**Conway Planning Commission  
Staff Report**

**7:00pm • April 17, 2017 • 810 Parkway Avenue**

**CONWAY CITY PLANNING DEPARTMENT REVIEW  
EDGEWOOD PARK PUD  
SUBMITTED BY: REFORM DEVELOPMENT GROUP**

### CONWAY CITY PLANNING DEPARTMENT REVIEW SOUTH STERLING PUD, PHASE 1 SUBMITTED BY: HAMBUCHEN PROPERTIES

Preliminary Plat

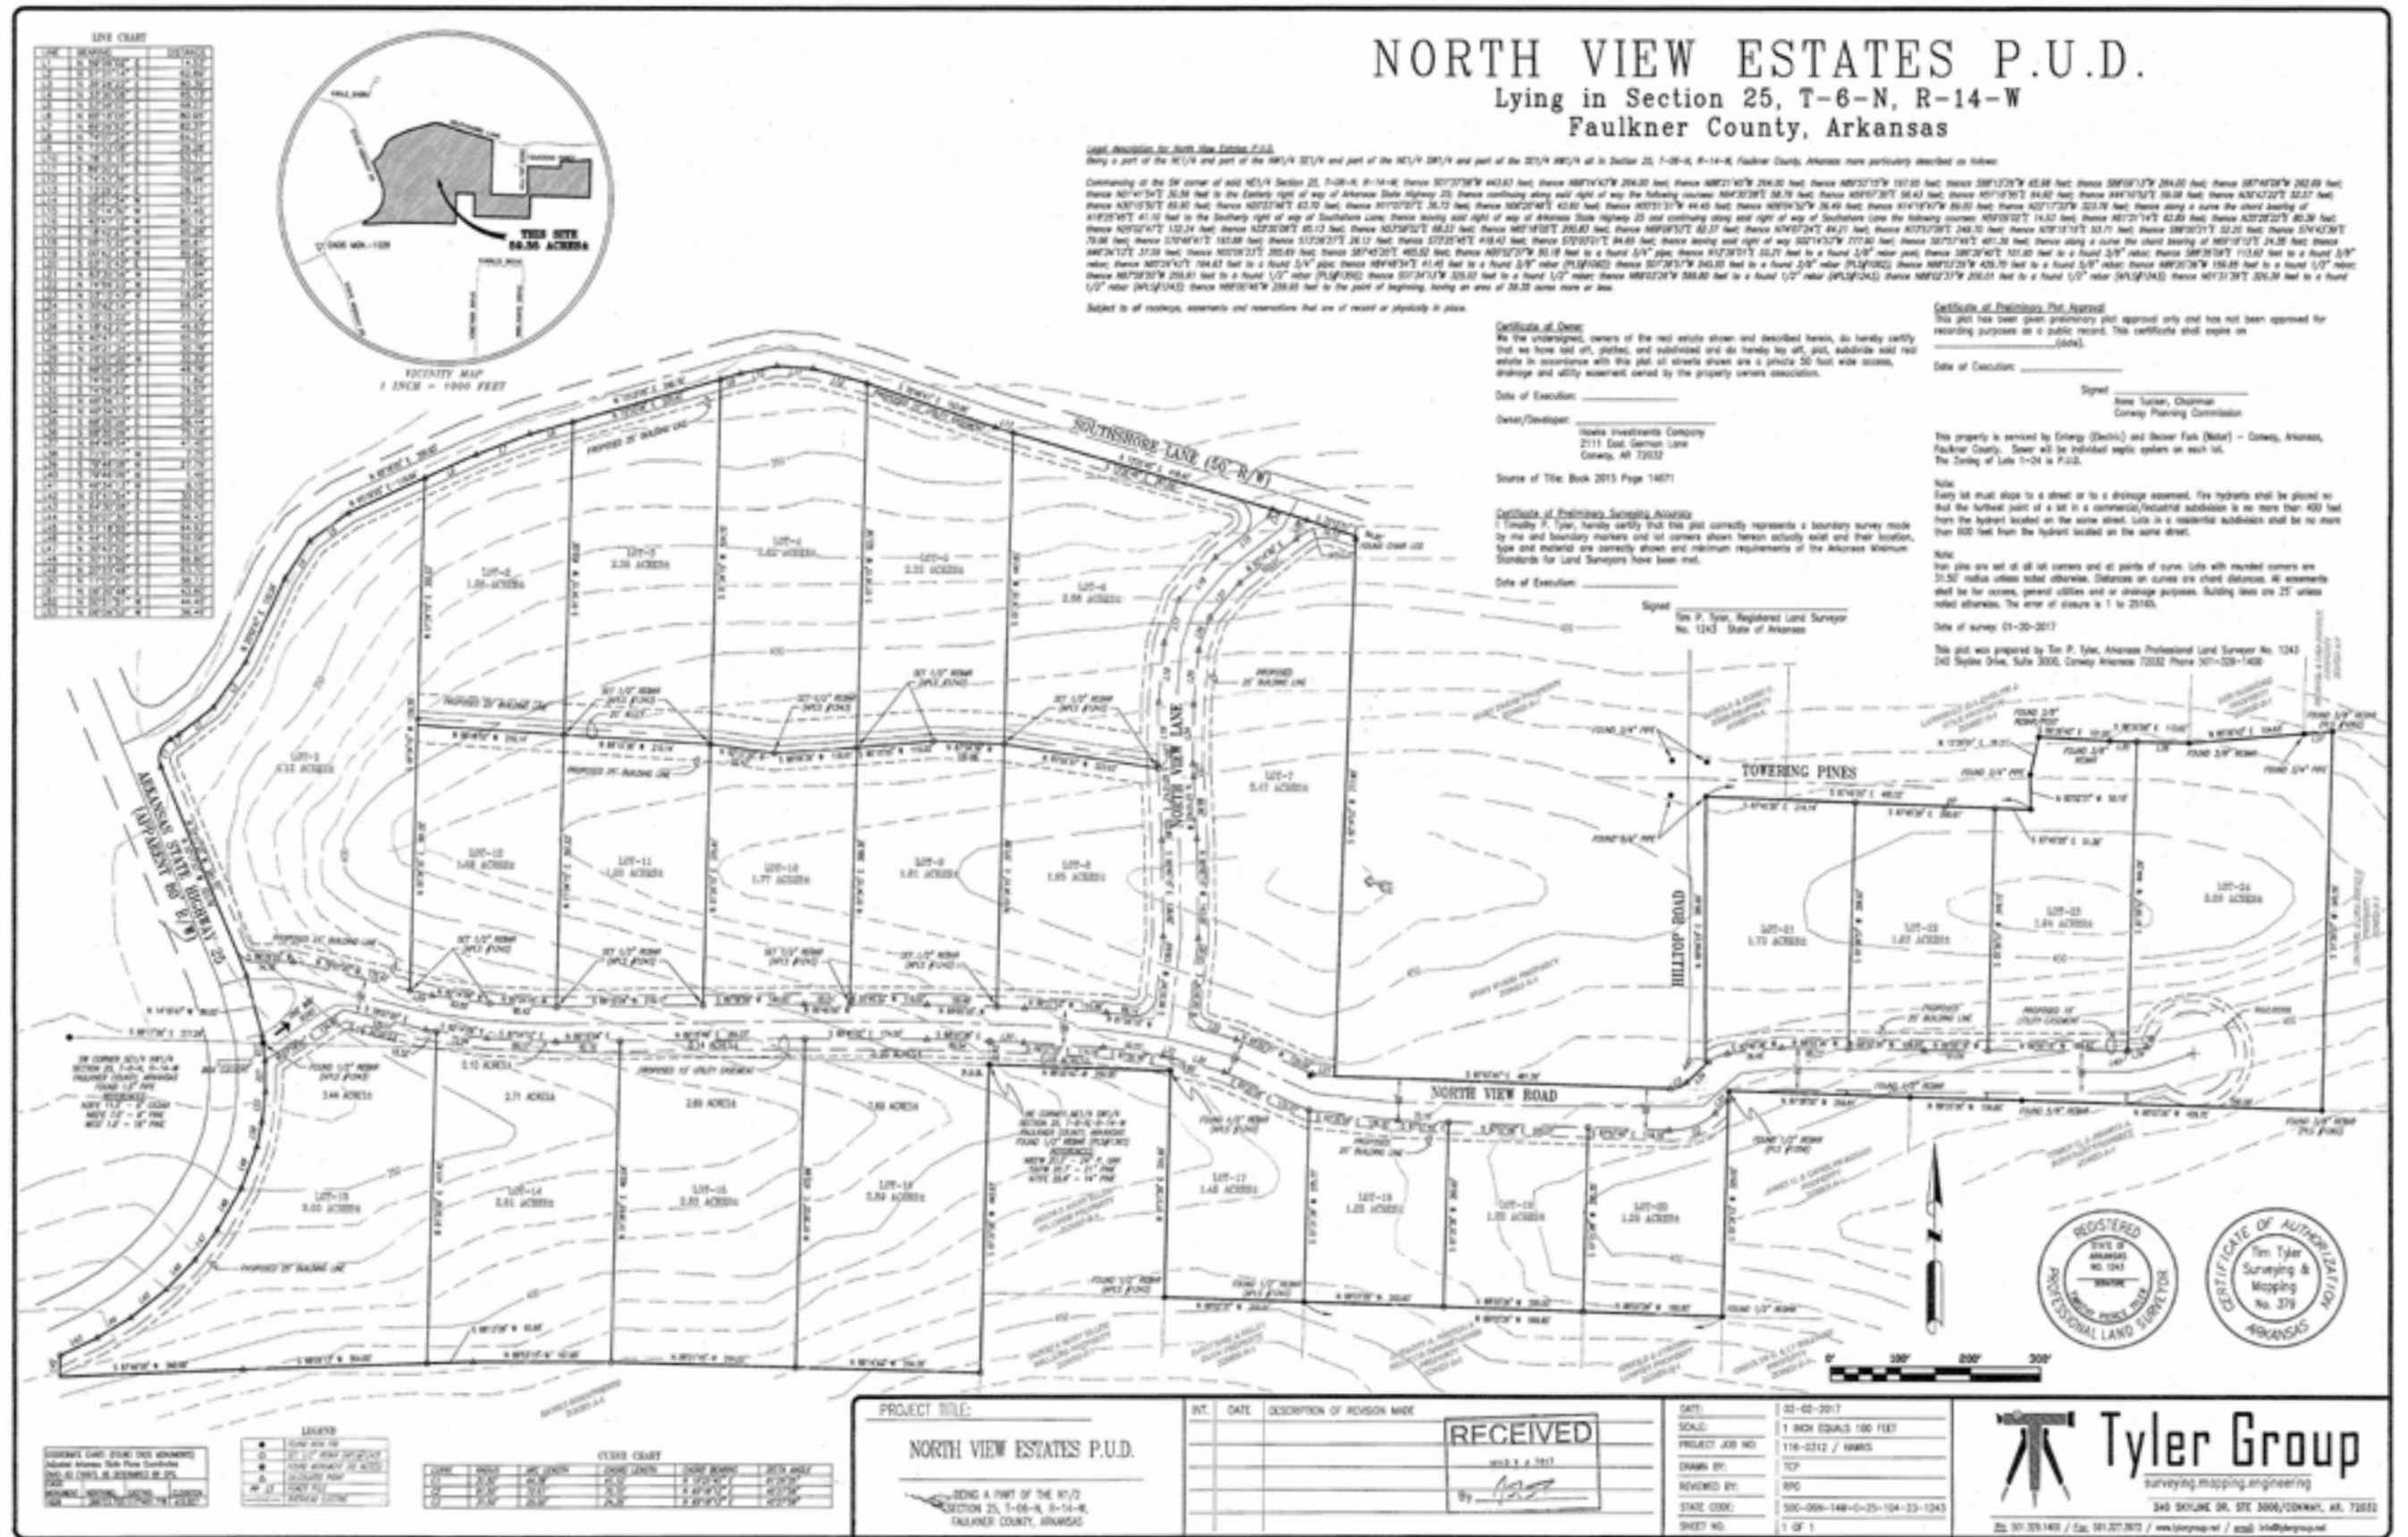
1. A legal description of the property with exact boundary lines, bearings and distances is needed. *Legal description needs to be corrected for the distance between L5 & L6; L6 is missing; L9 is missing.*
2. The present zoning classification, if any, of the land to be subdivided/replatted and of the adjoining land contiguous to the boundary of the proposed subdivision/replat is needed. *Lots 13-16 are PUD and inside City Limits. Remaining lots are in the county. Developer intends to annex remaining property into the city after platting is complete, with road improvements being Private Roads, not Public.*
3. Proposed easements are needed.
4. A minimum of two CAGIS monuments shall be placed in each subdivision or subdivision phase exceeding ten (10) acres.

28. Cul-de-sac streets or courts designed to have one end permanently closed or streets or street loops with a single access shall have a distance no greater than 650 feet from the point of access to the nearest point of the furthest lot with the distance measured along the shortest route within the street right-of-way. Exceptions: 1. A street may be up to 1120 feet in length with a right-of-way of 60 feet in width and with a paved width from back of curb to back of curb of 40 feet if it meets all other cul-de-sac requirements. 2. A residential street may be 1120 feet in length with 50 feet of right-of-way and 27 feet of paved width from back of curb to back of curb if all lots provide no less than 90 feet of width at the building line per dwelling unit and it meets all other cul-de-sac requirements. **North View Road is over 1120 feet long. Planning Commission must approve the Cul-de-sac road length, or this condition must be corrected.**

29. Any cul-de-sac over 750 feet in length must have fire department approval.
30. Where residential streets intersect other residential, collector or arterial streets, the curb radii at the intersection shall not be less than 28 feet.
31. Property line corners at street intersections shall be rounded with a radius of at least 28 feet.
32. The layout of streets shall conform to existing and proposed land uses for the area. *The City will need confirmation from the county of road layout, names, connections and restrictions including potential conflicts between Hilltop road and North View Road with adjacent property owners to the south.*

Proposed site plan

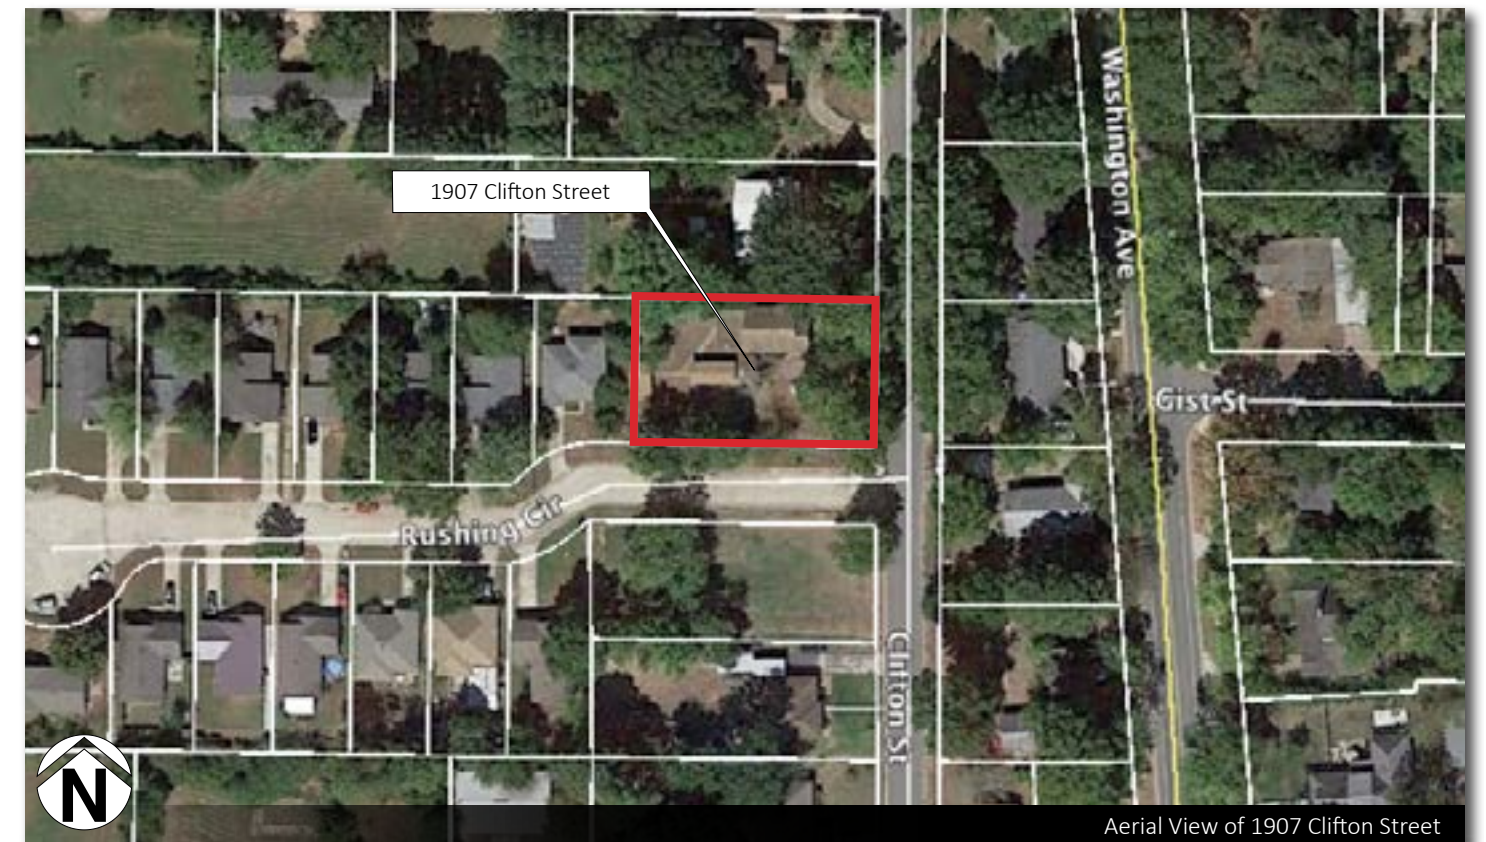
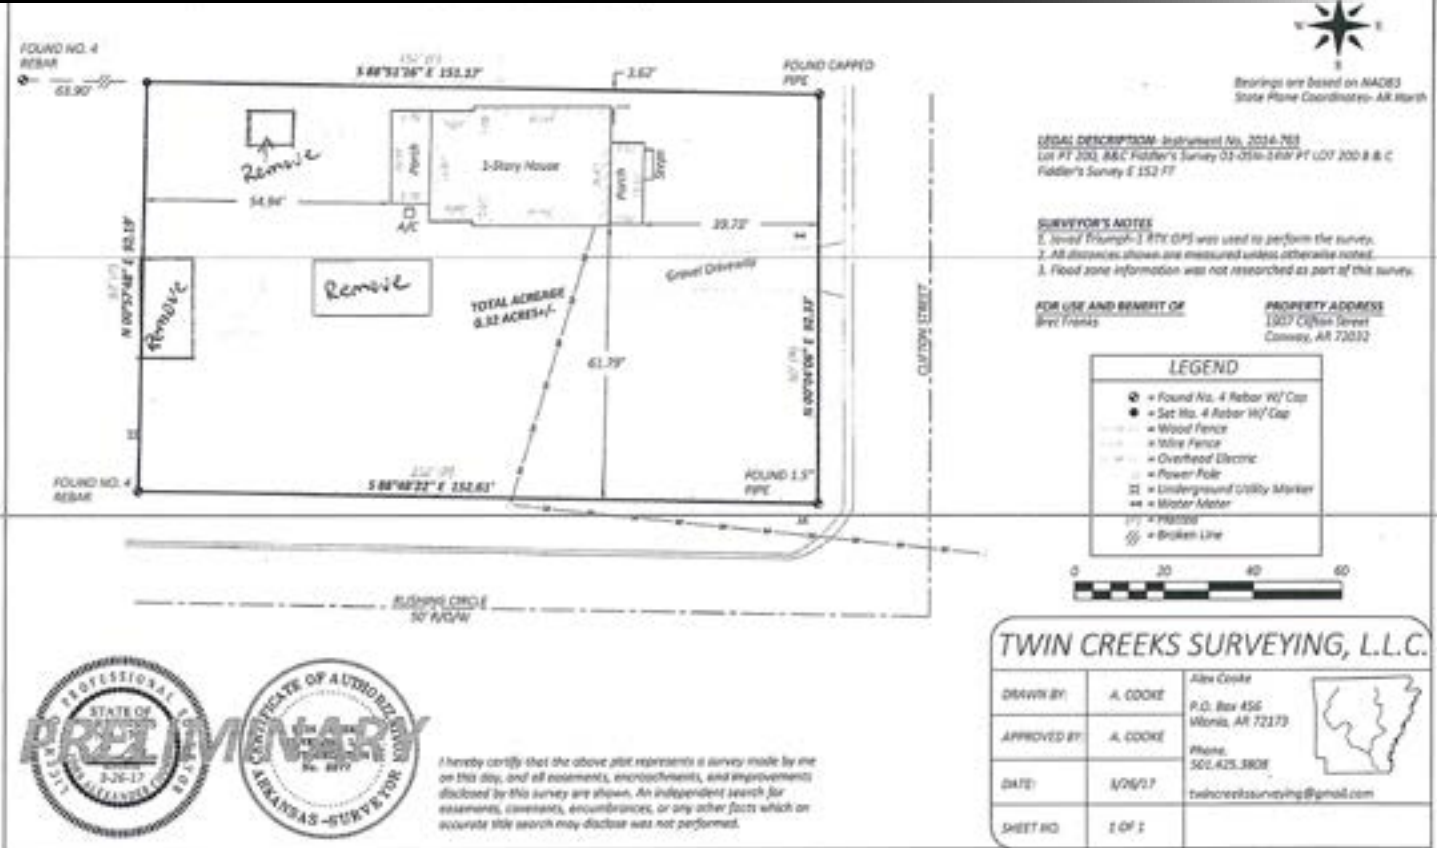
- An 11.36 foot variance on the exterior setback (Rushing Circle street side) of proposed house 1. *This reduced setback would leave approximately 25 feet of green space between the home and the Rushing Circle curb.*
- A 10 foot variance on the rear setback of proposed house 2. *This "rear" setback area could be seen as a "side" setback. If the lot were subdivided to allow a single family residence fronting Rushing Circle, a 6 foot side setback would be allowed. In effect, this "rear" setback is 4 feet wider than a required "side" setback.*

Due to the nature of the proposed cottage courtyard development, structure setbacks should be allowed as proposed. In order to effectively develop the approved denser development, these setbacks are necessary.

- 11.36 foot variance on the exterior setback (street side against a Rushing Circle) of proposed House 1.
- 10 foot variance on the rear setback of proposed House 2.
